RE: AC Hotel Midtown DC-2 CUP - Revisions

CONDITIONAL USE PERMIT APPLICATION

**AC HOTEL
MIDTOWN DC-2**

**March 1, 2023
Revised June 27, 2023**

CUP 3

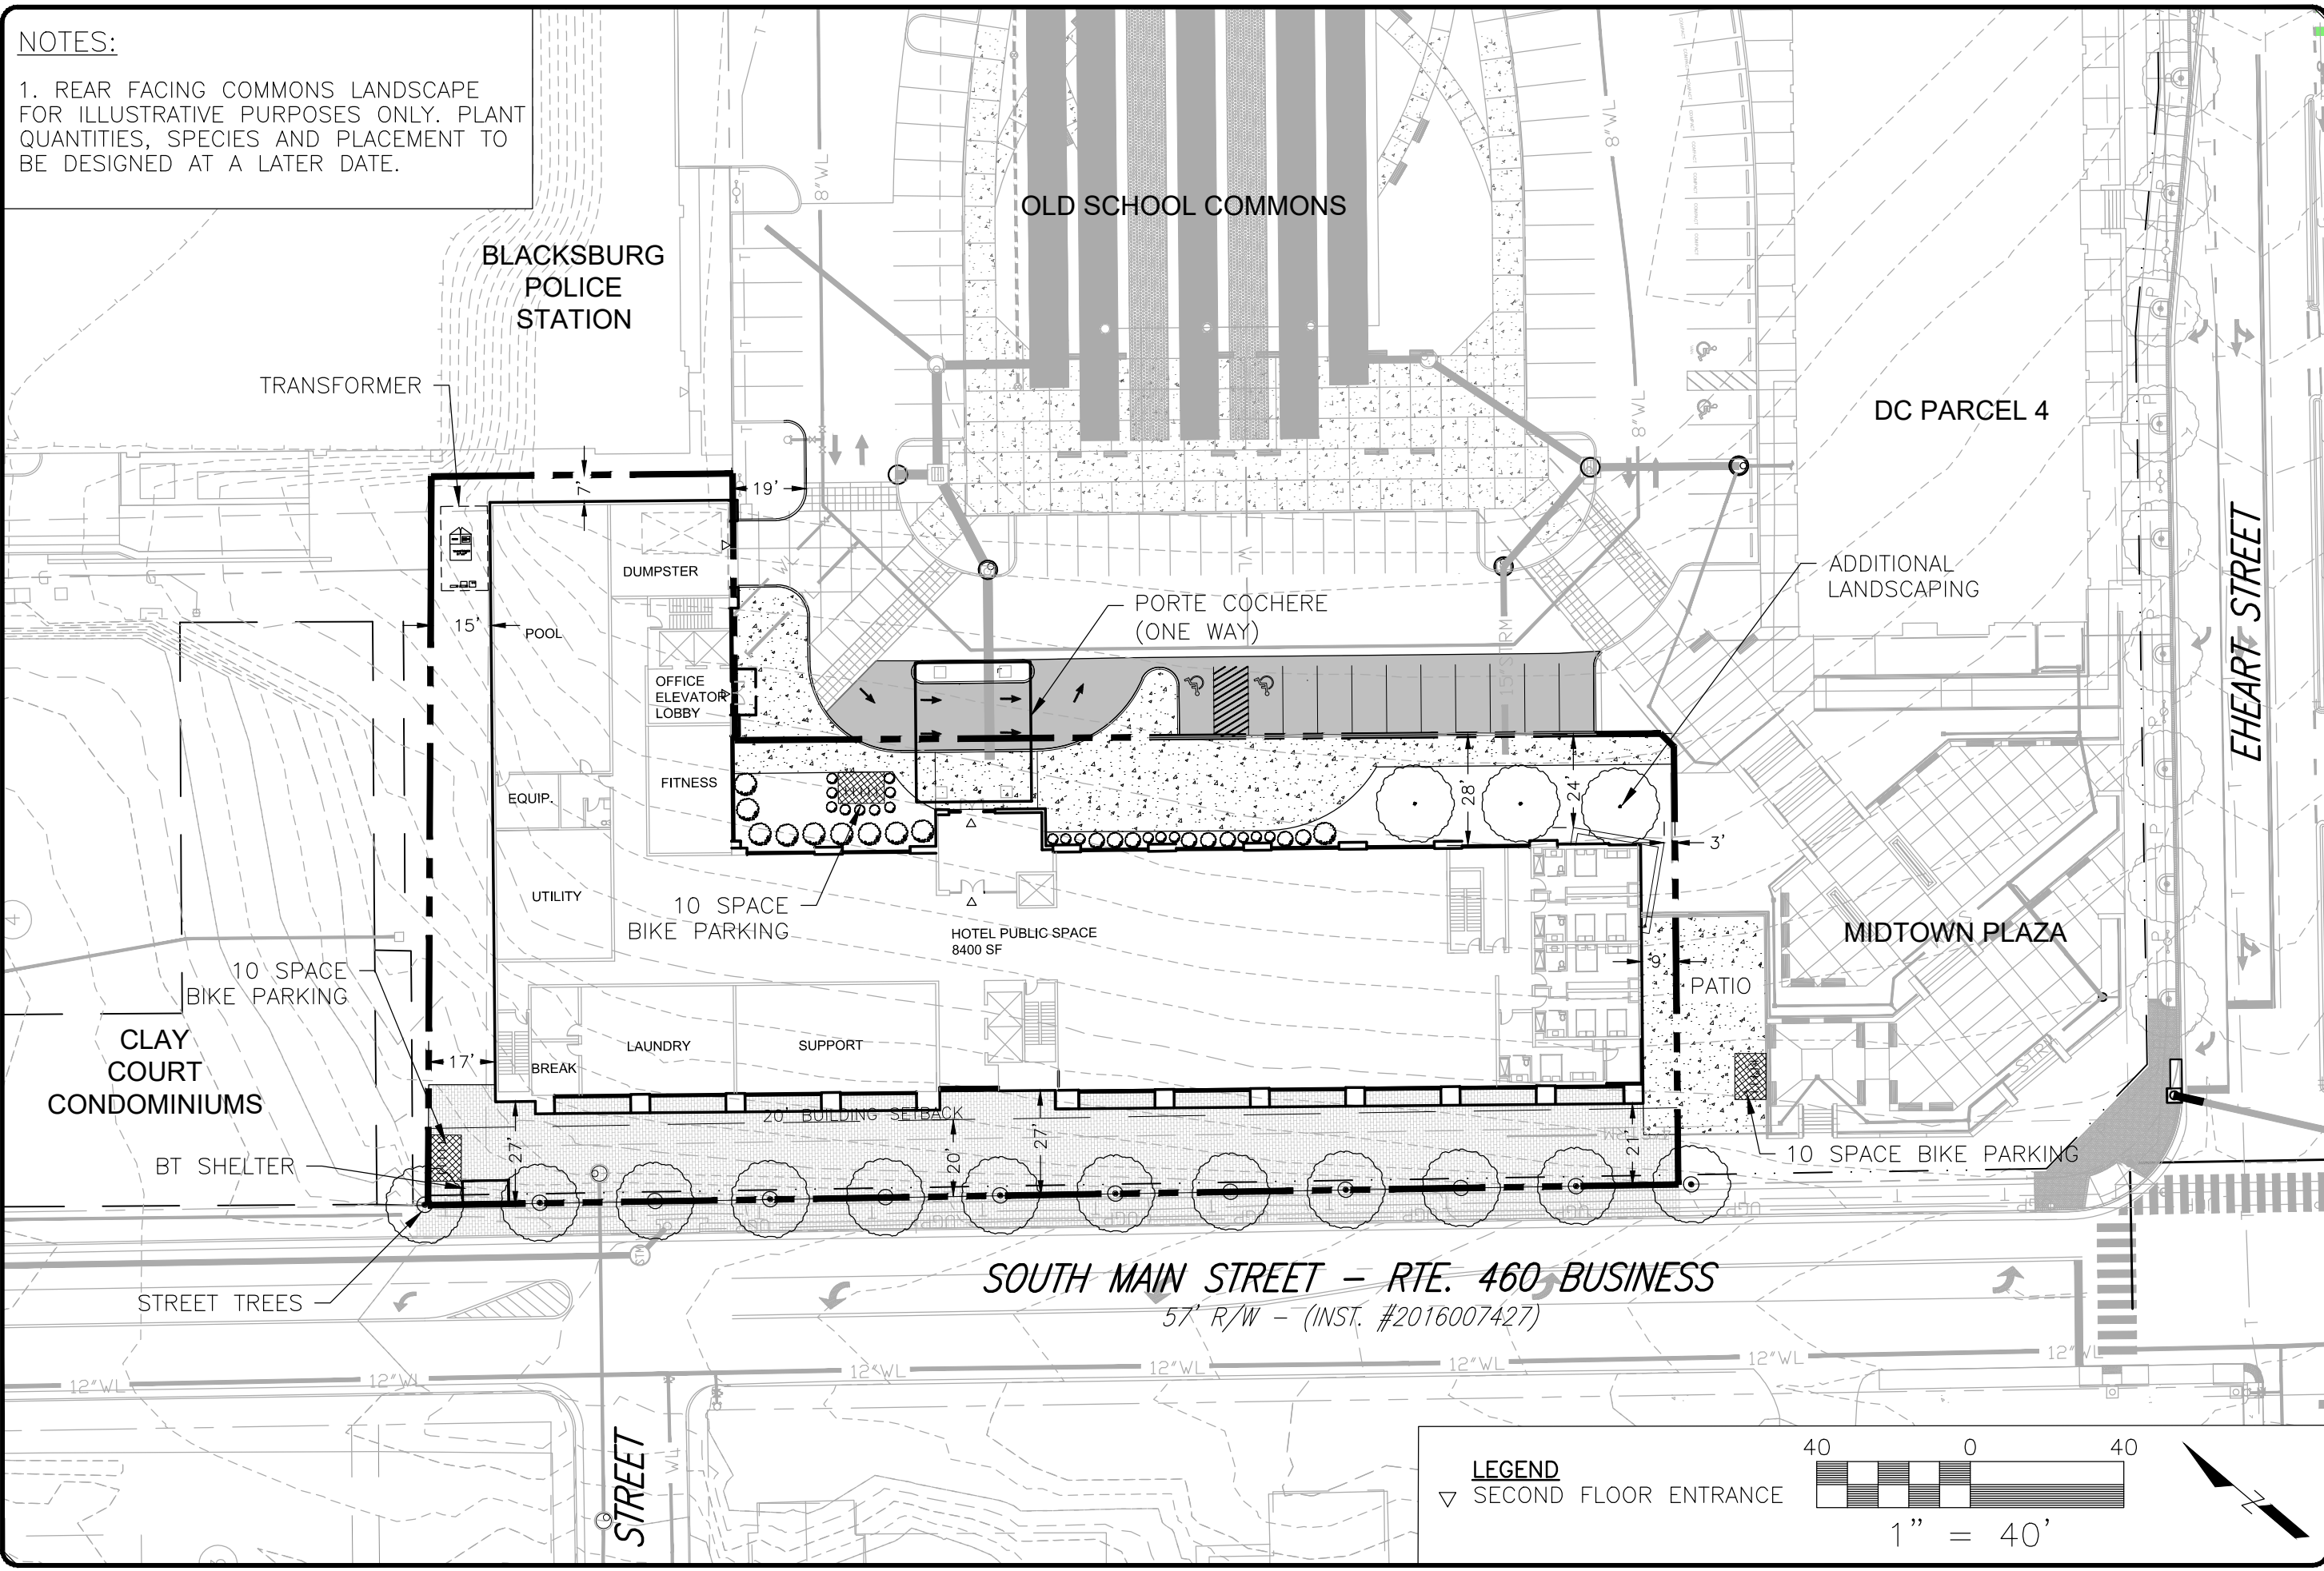
- 2) The masterplan drawing CUP3 has been revised to show the new south end feature.
- 3) Signage note has been updated on all drawings.
- 4) The Application text document has been revised as well to include the updated square footage numbers.
- 5) Façade material percentages chart shall be provided after Town Council Work Session on July 5, 2023.

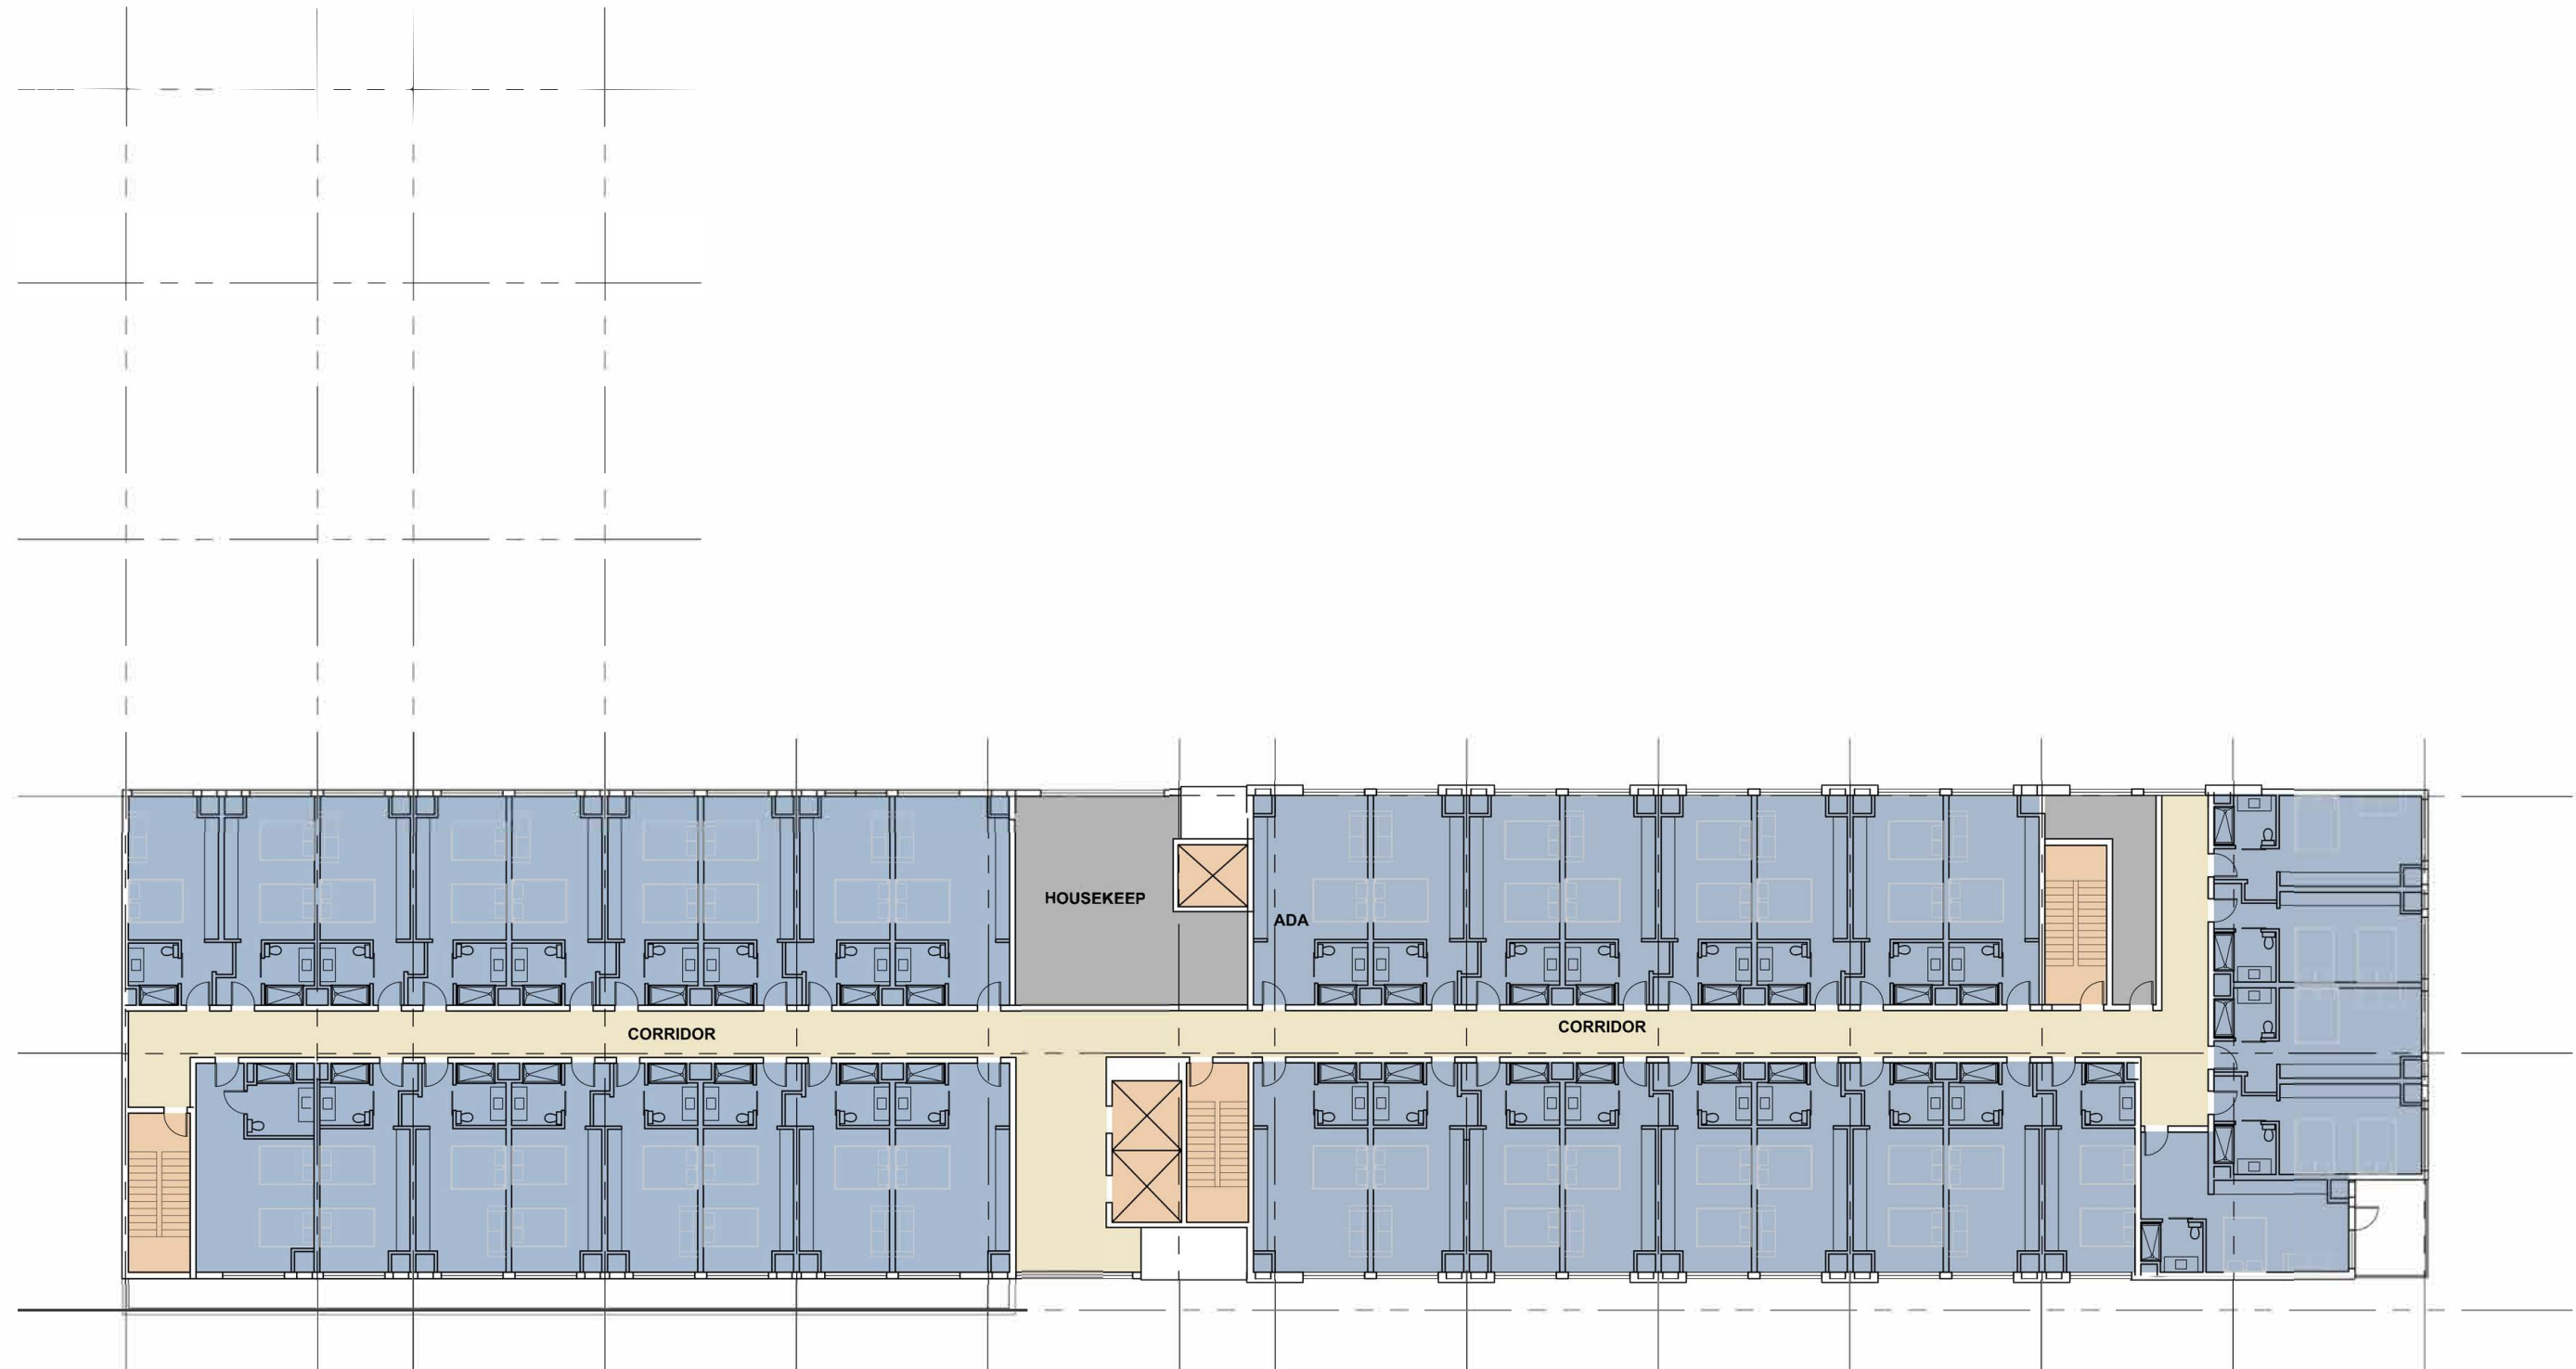
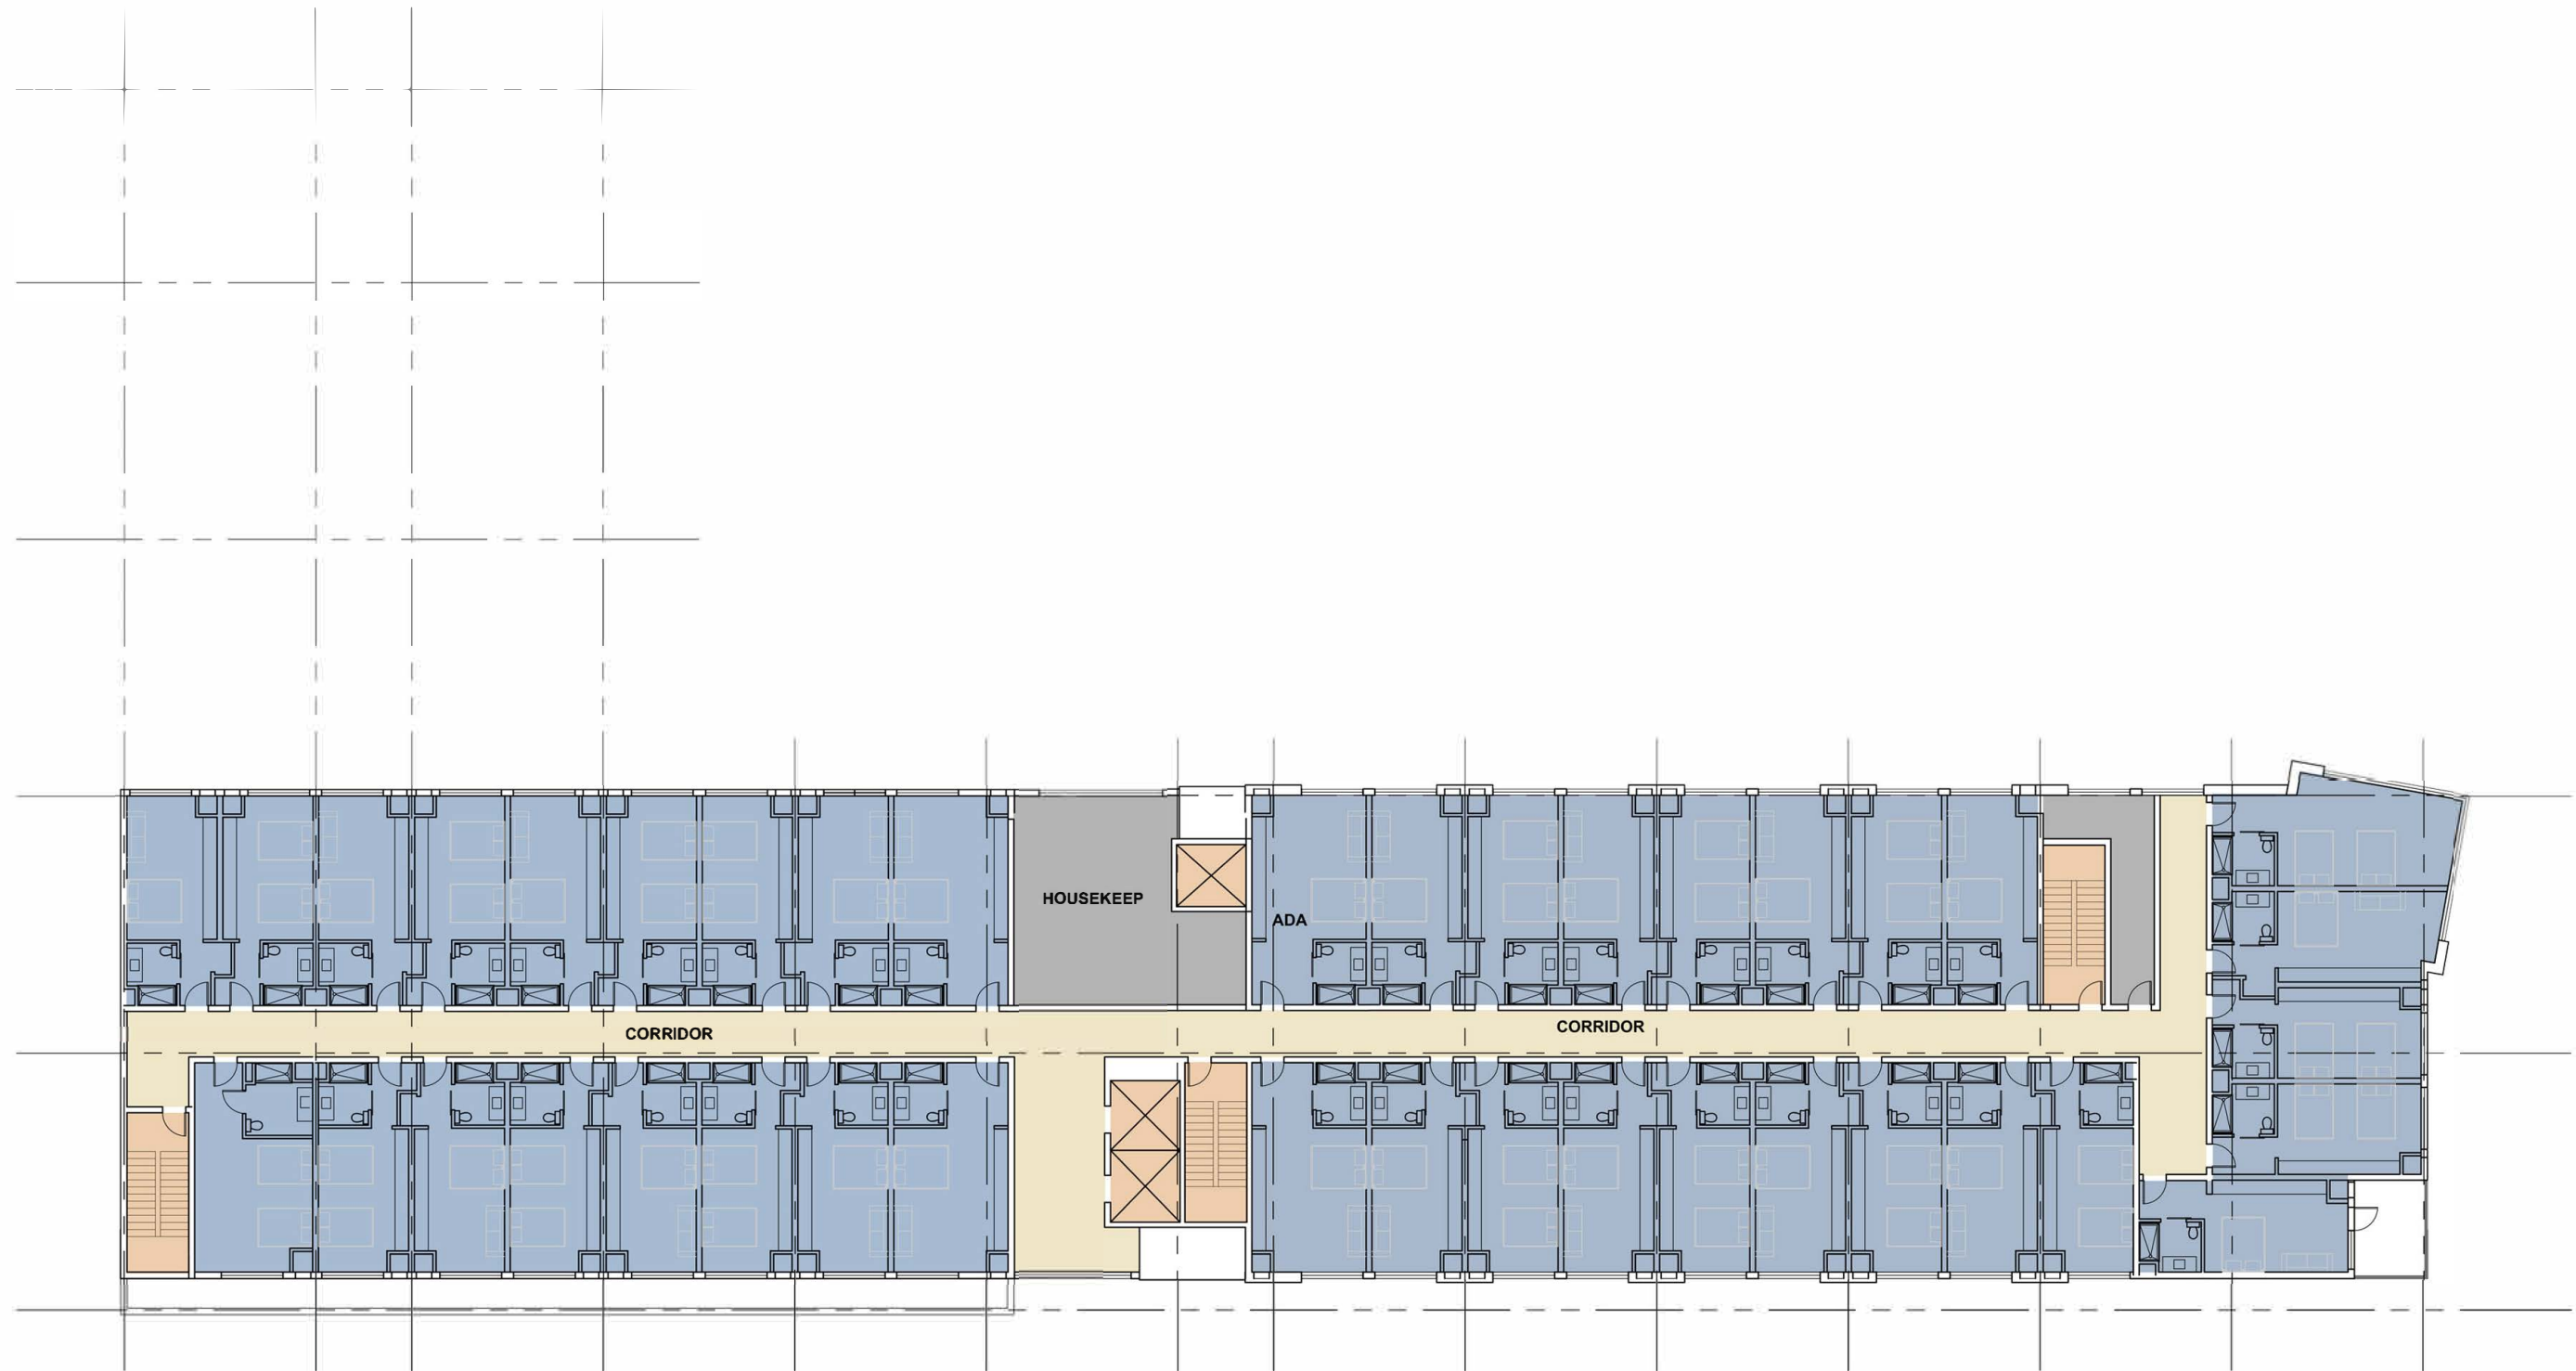
- An additional architectural feature has been added to the upper stories of the building on the southern façade to provide more visual impact and interest.
- Floor plans of the upper floors adjusted slightly to include this new architectural feature.
- Awning structures have been included on the southern façade within the outdoor patio area.
- Lighting has been shown on the interior wall of the patio area.
- The concrete wall along South Main Street has been removed from the perspective renderings and replaced with planter boxes.
- Landscaping is included on the perspective rendering showing the view from The Commons.
- The terracing walls have been removed from the rear of the patio and now match the planned grading and site plan. Landscaping has been shown on this slope.
